Ken Nichols
Principal, EQL Energy
3701 SE Milwaukie Ave, Suite A
Portland, OR 97202

Date: February 1, 2016

RE: Comments of EQL Energy, UE-141170, Puget Sound Energy 2015 Integrated Resource Plan.

Figure 1: Energize Eastside Problem is Eastside load growth

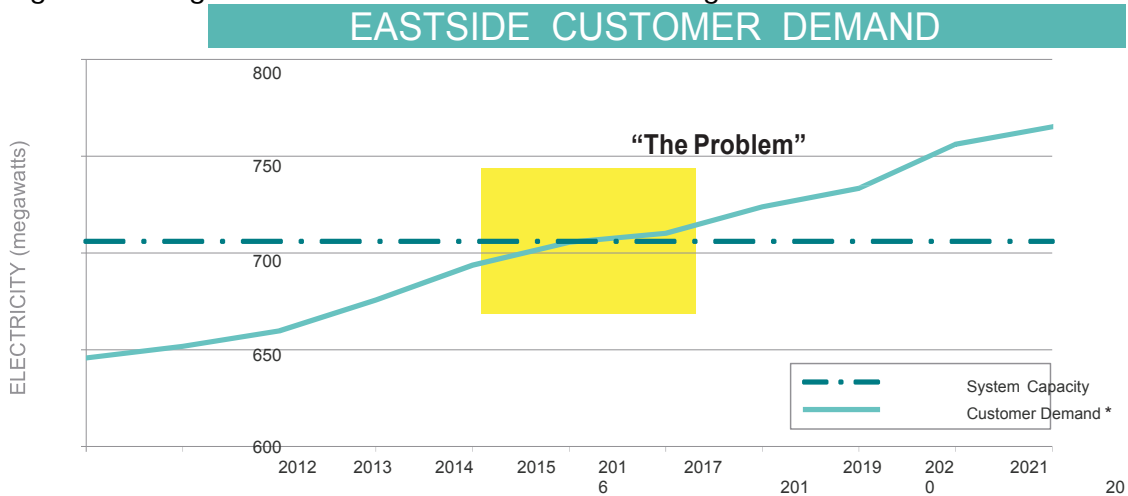
Energize Eastside is a transmission project that is addressing load growth on the eastside, see [Figure 1](#) from Eastside Needs Assessment Report. Its cost, estimated \$300MM, should be added to all supply-side resources outside this region, and excluded from resources that do not require it.

Figure 4: NW Power & Conservation Council Forecast Slide⁷

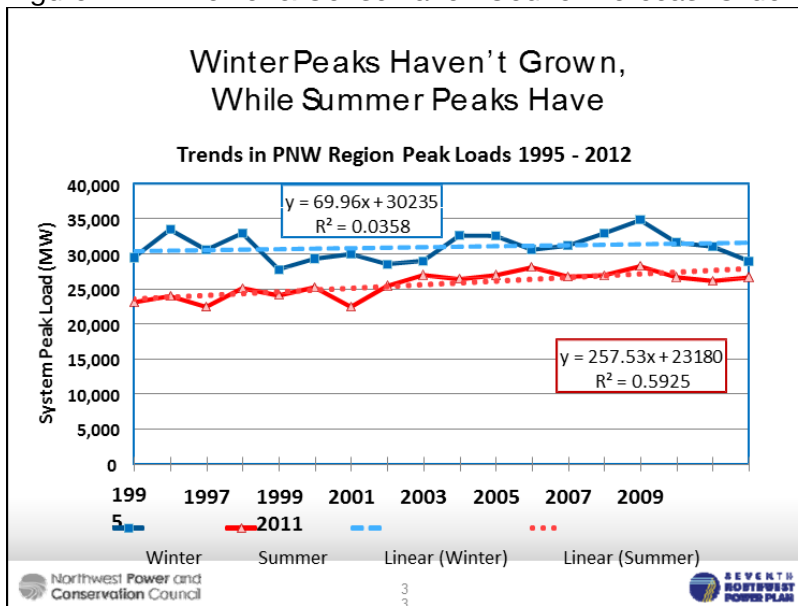
The NPCC winter peak load forecast uses a low to high range of 0.4 to 0.9% growth, and high range forecasts are not expected to reach the historical peak set in 2009 again until 2026.⁶

Figure 9: Bellevue Substation Peak Load Heat Map (2006)

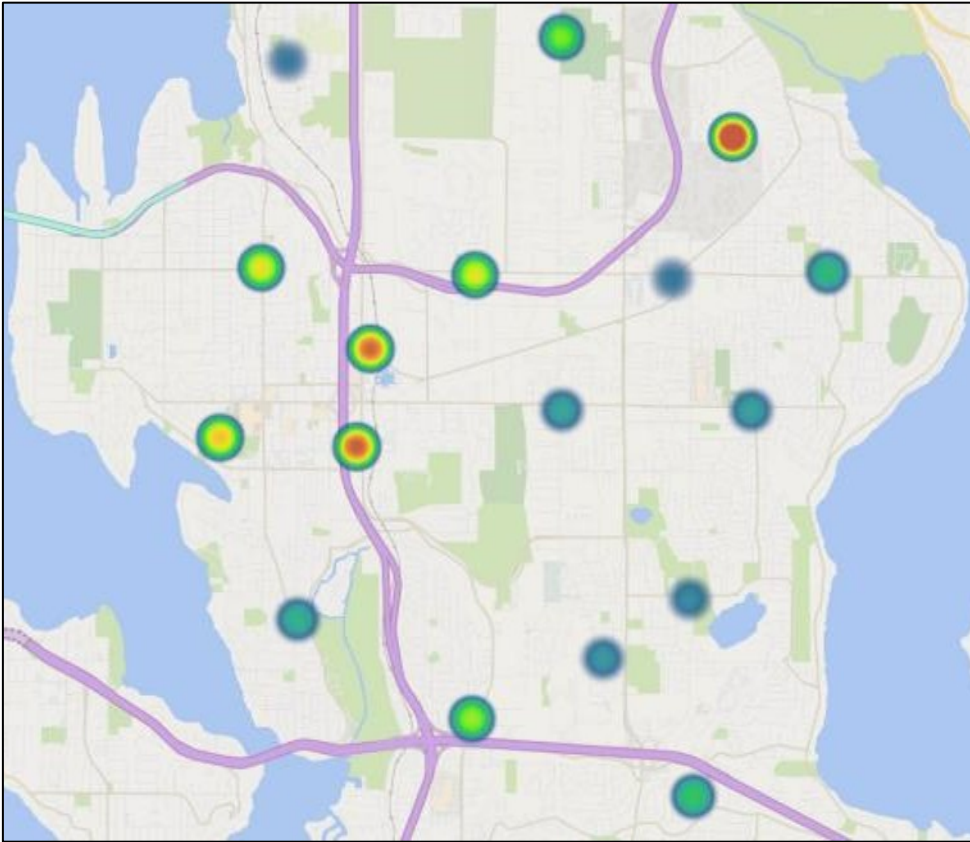
Figure 9 below shows substation locations in the Eastside area that have historically recorded higher load and may be more likely to serve larger customers sites with high DER potential such as commercial/industrial, multifamily residential, institutional, government, campus and hospital loads.

Figure 16: Sample DER Contribution to Winter Peak Day Load Shape³²

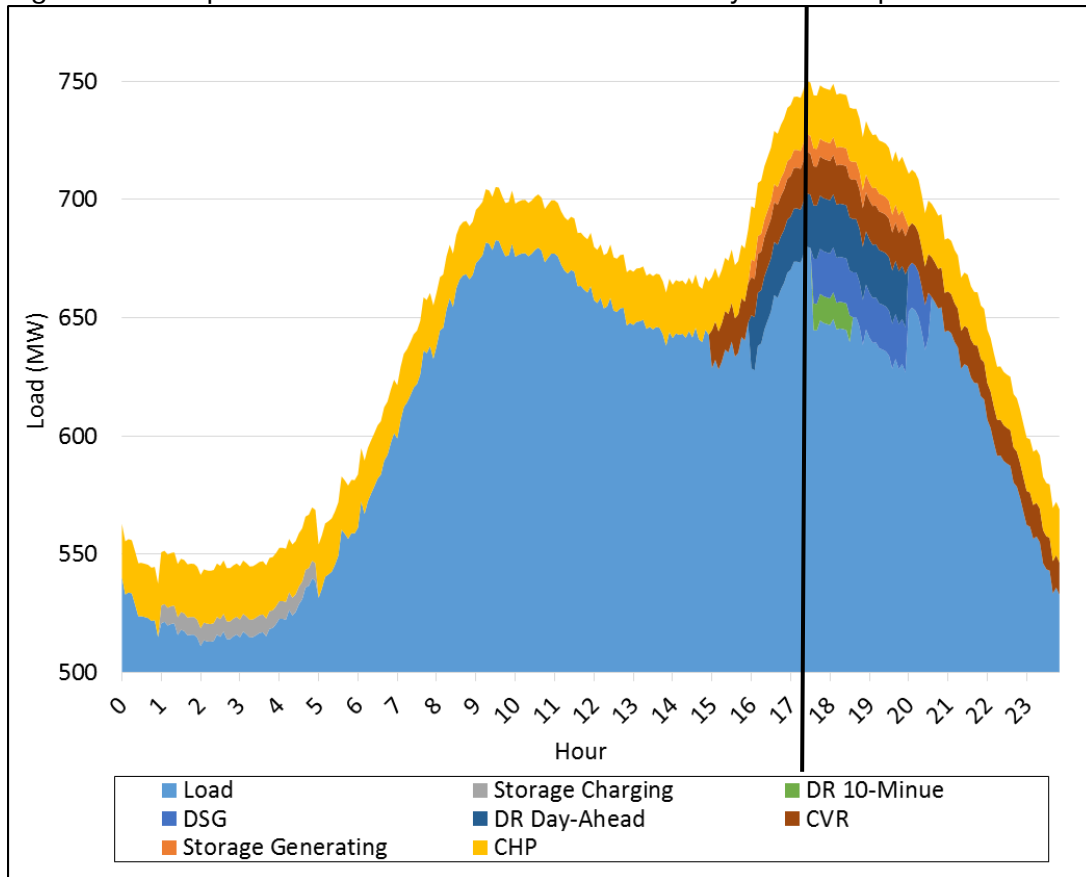
Figure 16 shows a sample peak day load shape for the Puget Sound area with a stack of resources deployed both throughout the day and during a dispatch at 5:30PM during the peak to depict what could happen in the event of an outage. Note the duration of DER response required after dispatch as load decreases into nighttime hours.

Figure 18: Generation Levels³⁷

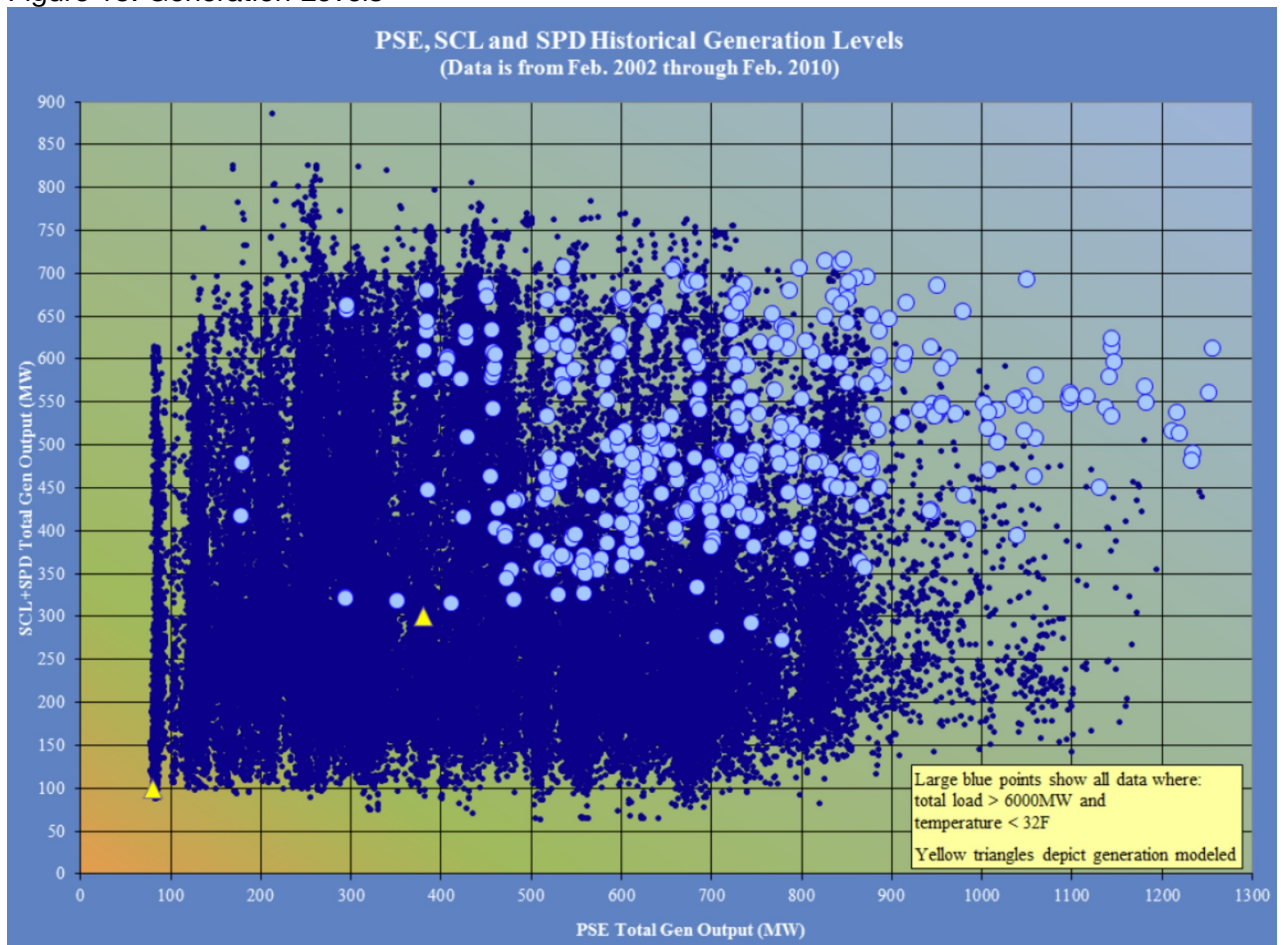
Figure 18 shows historical generation levels for PSE, Seattle City Light, and Snohomish PUD, and distinguishes levels that occurred when temperatures were below 32°F and loads were likely to be high. One of the yellow triangles is positioned at approximately 680 MW of total generation, used for a number of ColumbiaGrid studies that were assessing regional transfer capability and did not address local load service. One key conclusion to be drawn from this chart is that historical data shows 680 MW is on the low side for generation assumed to be running during cold winter weather and supports the study request for higher levels described below.
